# LEE'S SUMMIT MISSOURI®

## Development Services Staff Report

<b>File Number</b>	PL2025-340
<b>File Name</b>	PRELIMINARY DEVELOPMENT PLAN – John Knox Village – Country Club Corridor Hybrid Villas
<b>Applicant</b>	SFCS, Inc
<b>Property Address</b>	Southeast corner of NW Chipman Road & NW Pryor Road
<b>Planning Commission Date Heard by</b>	April 9, 2026 Planning Commission and City Council
<b>Analyst</b>	Adair Bright, AICP, Senior Planner

Figure 4 – Site Plan showing angled head-in parking

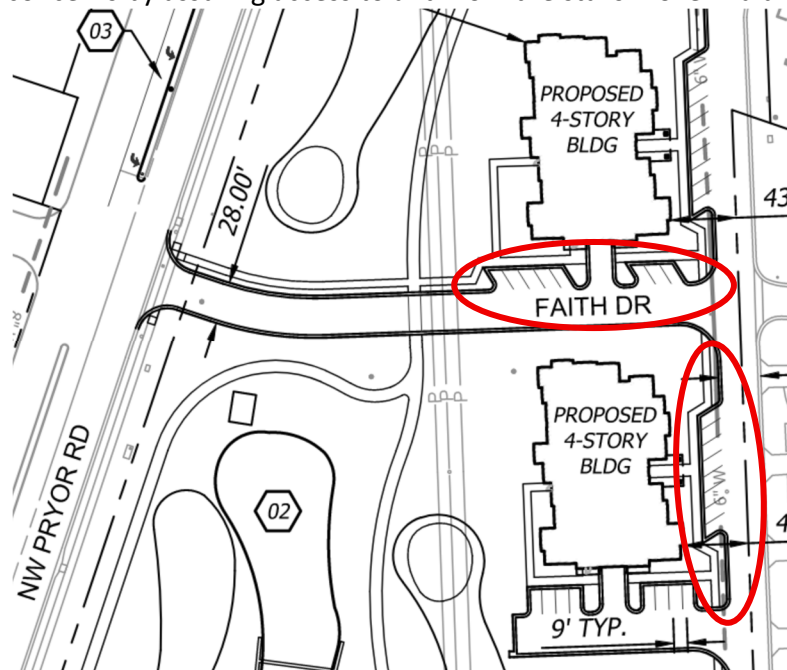
1. The applicant has requested a modification to UDO Sec. 8.620.A – Parking Lot Design, Head-In Parking
  - **Requirement** – Head-in parking from any public right-of-way or private street shall not be permitted, except that the use of head-in parking in the downtown area may be considered on a case-by-case basis.
  - **Proposed** – The applicant is proposing head-in angled parking on NW Faith Drive and NW Shamrock Ave.
  - **Staff Recommendation** – Staff is supportive of the proposed modification as head-in angled parking is an existing condition elsewhere in John Knox Village and is being provided to meet the required quantity of parking stalls as required by the UDO. The angled stalls minimize safety concerns by assuring access to and from the stalls move in a uniform direction.

1. Development shall be in accordance with the preliminary development plan with an upload date of March 20, 2026.
2. A modification shall be granted to UDO Sec. 8.620.A to allow for angled head-in parking from NW Faith Drive and NW Shamrock Avenue.
